ADDENDUM No. 1

ITB No. 4517

First Sister Lake Stormwater Retrofit

1
5 SITE PREPARATION PLAN

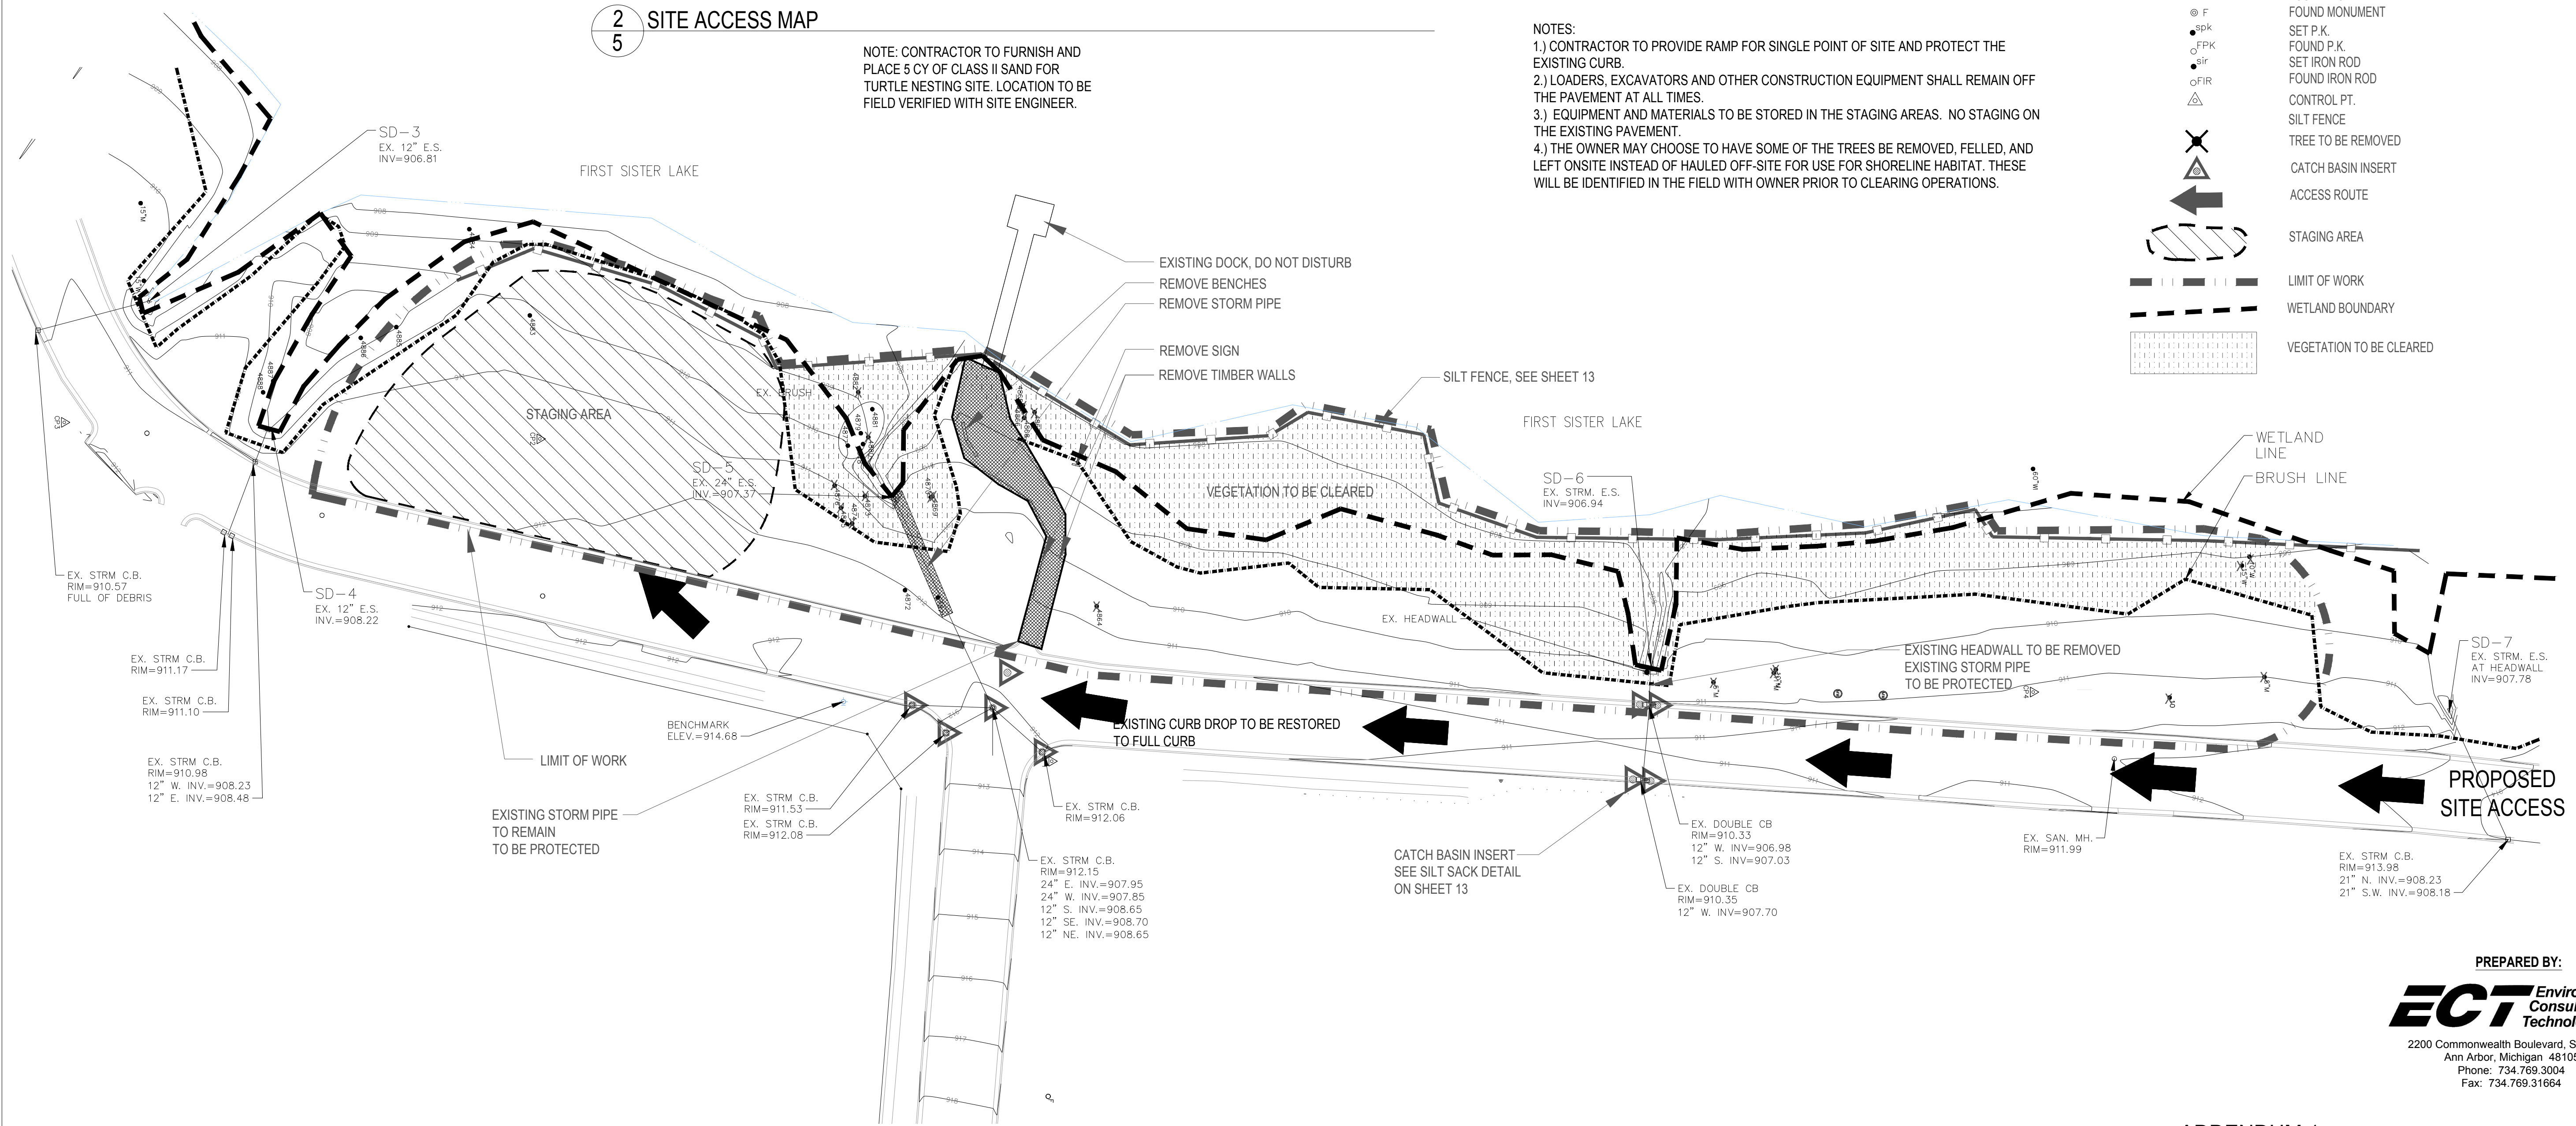
Section/Page(s)	Change
Plan Sheet 5	Replace with new Sheet 5, Labelled Addendum 1 Limits of work revised. Note added regarding felled trees.
Plan Sheet 6	Replace with new Sheet 6, Labelled Addendum 1 Limits of work revised. Added note regarding sand placement. Added note regarding curb replacement.
Plan Sheet 8	Replace with new Sheet 8, Labelled Addendum 1 Seed mix revised.
Bid Form, BF-1	Replace with new page BF-1, Labelled Addendum 1 Include pay items for sand and curb

NOTE: CONTRACTOR TO FURNISH AND PLACE 5 CY OF CLASS II SAND FOR TURTLE NESTING SITE. LOCATION TO BE FIELD VERIFIED WITH SITE ENGINEER.

1 PROPOSED PLAN
 6

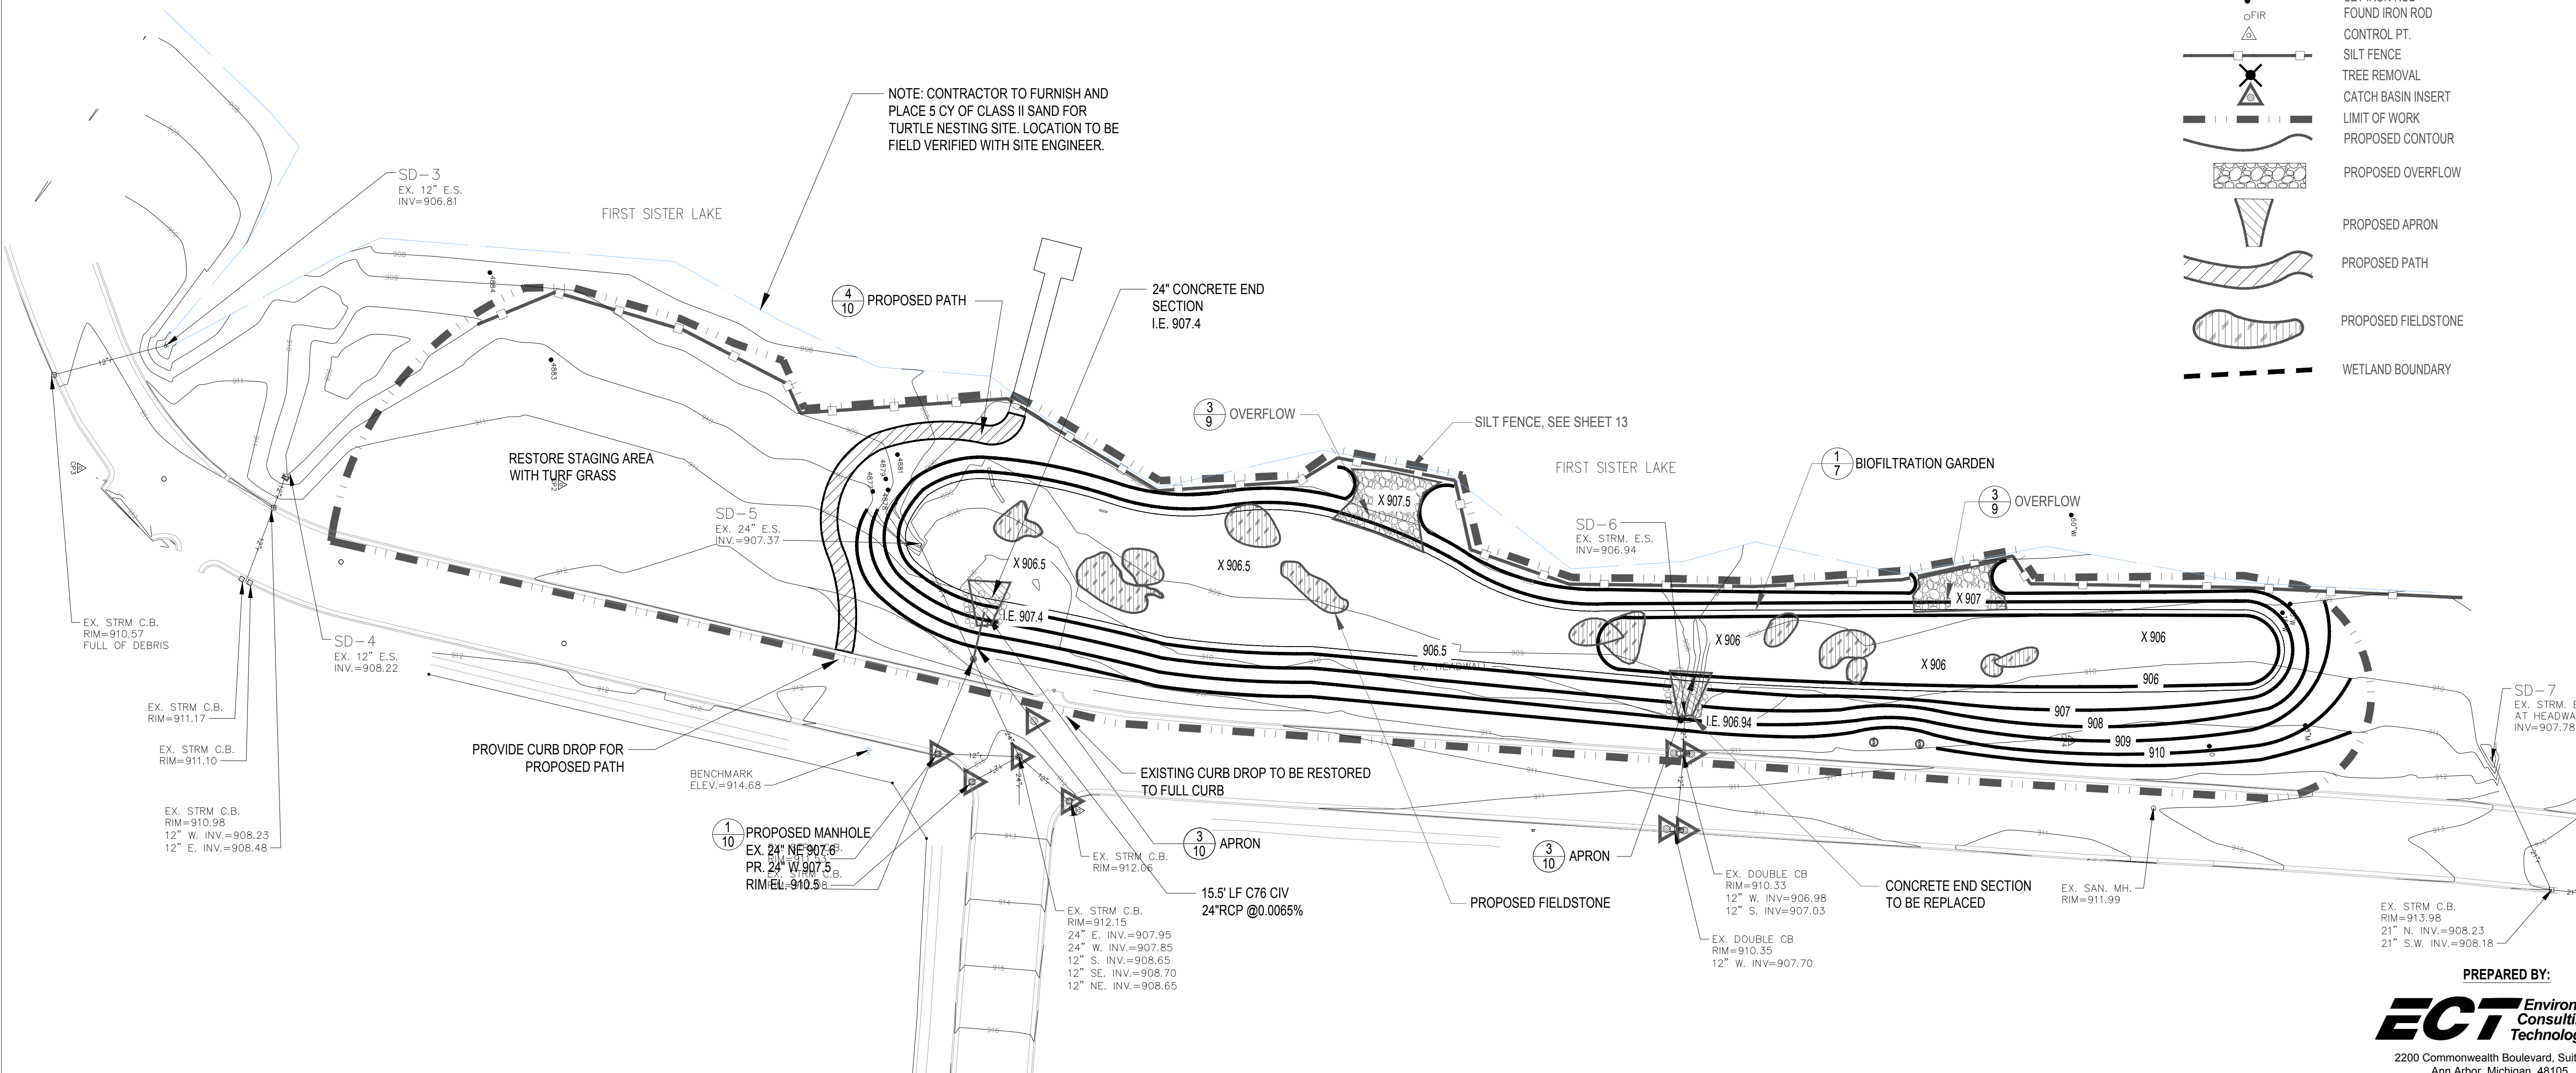
NOTE: CONTRACTOR TO FURNISH AND PLACE 5 CY OF CLASS II SAND FOR TURTLE NESTING SITE. LOCATION TO BE FIELD VERIFIED WITH SITE ENGINEER.
